Service Bulletin #185

Problem: Traction Drive Belts Come Off Engine Pulley On Snowthrowers

Units Involved: 55207, 55325 & 55326 Tecumseh Powered Snowthrowers

12062 BELT FINGER

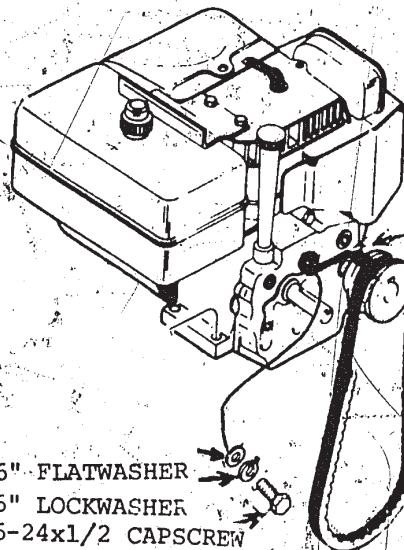
Reports have been received concerning the 212221 traction drive belt coming off the engine pulley upon declutching on the above models.

We have found that the effective overall length of the belt in some cases has permitted it to come off the engine pulley while declutching. Installation of a 12062 belt finger using common hardware as shown in the illustration below, will retain and prevent the belt from coming off. The engine block is tapped to accept mounting in the location shown.

A change is also being made by us on the overall length of the 212221 belt to reduce the amount of slack which presently exists. All future orders will be filled with new length belts.

NOTE: SET MAX. 1/8" AWAY IN ENGAGED POSITION

(70685) 5/16" FLATWASHER  
(70646) 5/16" LOCKWASHER  
(70197) 5/16-24x1/2 CAPSCREW
